Access Compliance Report

Public Rights-of-Way

(Curb Ramps)

Intersection ID: 32285	Main Street: ALLYSON_PARK_DR	Cross Street: AUBURN_TOP_LN	Location: SE
ADA ID: C404D381D618	Ramp Type: PerpDiag	Initial Pass/Fail: Fail	Overall Compliance: No
Codes/Mitigation Info/Possible Solution		Field Measurements/Component Compliance	
Severity Score: 33.75

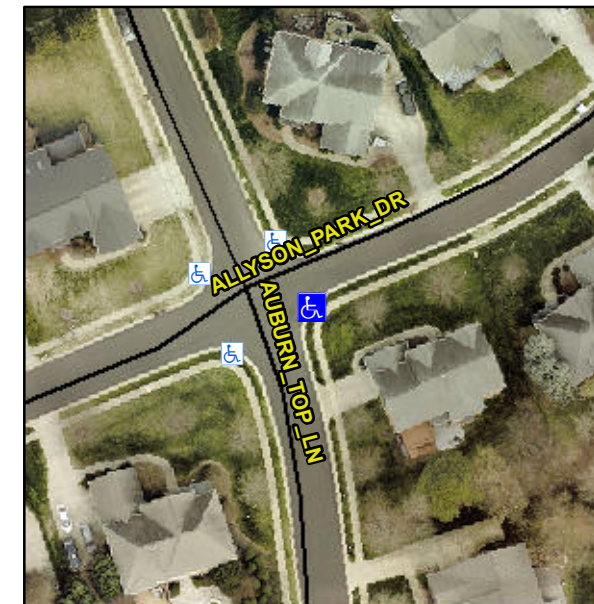
Not Found, R304.5.1, R304.2.2, R304.5.3

Compliance	Description	Data	Compliance	Description	Data
N/A	Ramp Length (in)	51.0	No	Ramp Slope (%)	9.2
No	Ramp Width (in)	41.0	No	Ramp XSlope (%)	6.1
N/A	Flare Type LT	N/A	N/A	Flare Type RT	N/A
N/A	Flare Slope LT (%)	N/A	N/A	Flare Slope RT (%)	N/A
N/A	Flare Traversable LT?	N/A	N/A	Flare Traversable RT?	N/A
N/A	Landing Length (in)	N/A	N/A	DWS Provided?	N/A
N/A	Landing Width (in)	N/A	N/A	DWS Contrast?	N/A
N/A	Landing Slope (%)	N/A	N/A	DWS Length (in)	N/A
N/A	Landing X Slope (%)	N/A	N/A	DWS Full Width?	N/A
N/A	Landing Curb? (Y/N)	N/A	N/A	DWS Offset (in)	N/A
N/A	Shared Landing?	N/A			
N/A	Gutter Ponding?	N/A	N/A	Gutter Slope (%)	N/A
N/A	Gutter Lip Ht (in)	N/A	N/A	Gutter X Slope (%)	N/A
N/A	Painted X Walk1?	No	N/A	Painted X Walk2?	No
	X Walk 1 Direction	To N		X Walk 2 Direction	To W
N/A	X Walk 1 Width (in)	N/A	N/A	X Walk 2 Width (in)	N/A
	X Walk 1 Slope (%)	5.8		X Walk 2 Slope (%)	0.7
	X Walk 1 X Slope (%)	3.8		X Walk 2 X Slope (%)	4.9

Remove & Replace Curb Ramp With Two New Directional Ramps or Equivalent.
